24 CFR Part 3280

Manufactured Home Construction and Safety Standards, Test Procedures for Roof Trusses

ACTION: Final rule.

Figure 3280.402(b)(1) – Test fixture for testing trusses singly

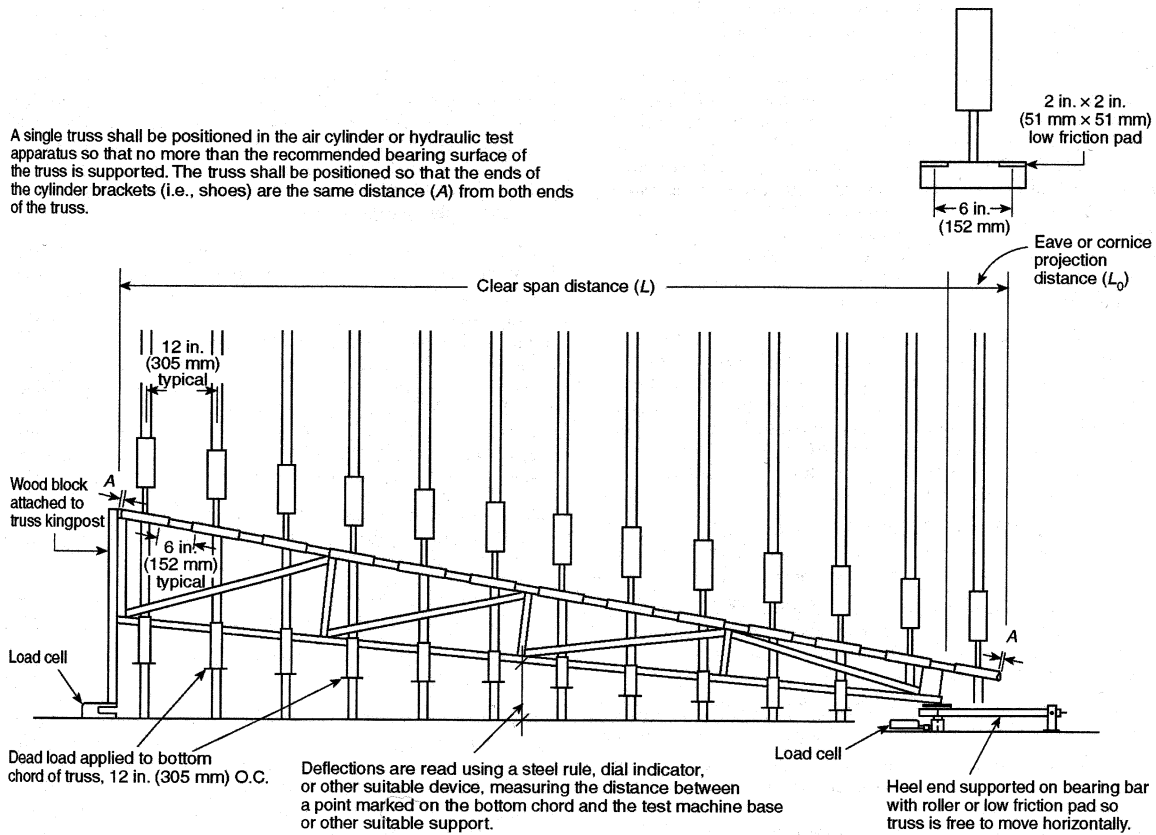
Question 2: Should the spacing between hydraulic or pneumatic cylinders for the test fixture be increased from 12 inches to 24 inches in Figures 3280.402(b)(1) and 3280.402(b)(3)? Should the distance between friction pads along the top chord of the truss of the test fixture be increased from 6 inches to 12 inches in Figure 3280.402(b)(1)? Should the distance between 1-inch straps attached around the cylinder shoe and the top chord of the truss of the test fixture be increased from 6 inches to 12 inches in Figure 3280.402(b)(3)?

Comment. The commenters indicated that the loading cylinders should be maintained at 12 inches and that the loading shoes should be 6 inches long with loading pads at each end to provide a more realistic simulation of a uniformly distributed loading upon the truss.

HUD Response: HUD agrees with the commenters that the cylinders spacing needs to be maintained at 12 inches to more closely simulate uniform loading of the truss, and the loading shoes need to be 6 inches long with loading pads at each end, and has specified these requirements in the final rule.

(1) When trusses are tested singly, trusses shall be positioned in a test fixture, with supports properly located and the roof loads evenly applied. See Figure 3280.402(b)(1).
